NC015 Breaker Replacement Program

Potential problems on certain NC015 and NCO15CP Breakers may exist

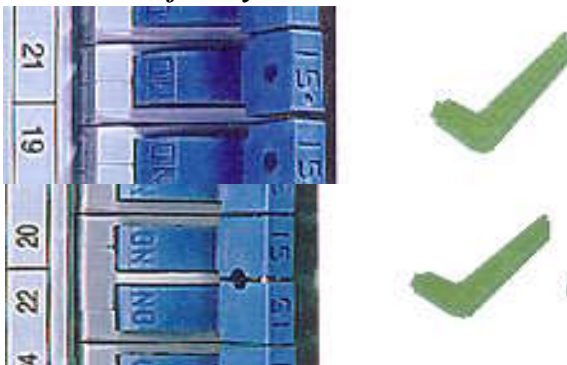
The affected circuit breakers are *Federal Pioneer NC015 and NC015CP, Single Pole Rated 15A, Stab-Lok Circuit Breakers* - Manufactured between August 1, 1996 and June 11, 1997.

BLUE coloured handle.

Replacement breakers are identified by a hole drilled in the handle (Blue color)

Check for a hole on the blue handle, as illustrated with check marks.

Breakers with black handles are not an issue

To cease selling and quarantine any suspect stock of NC015 and NC015CP (*including FastPaks*) as identified above; and contact your local Schneider Canada sales representative to return these.

Will not accept these breakers at any installation and will be informing contractors/customers of the problems and necessary action they should be taking.
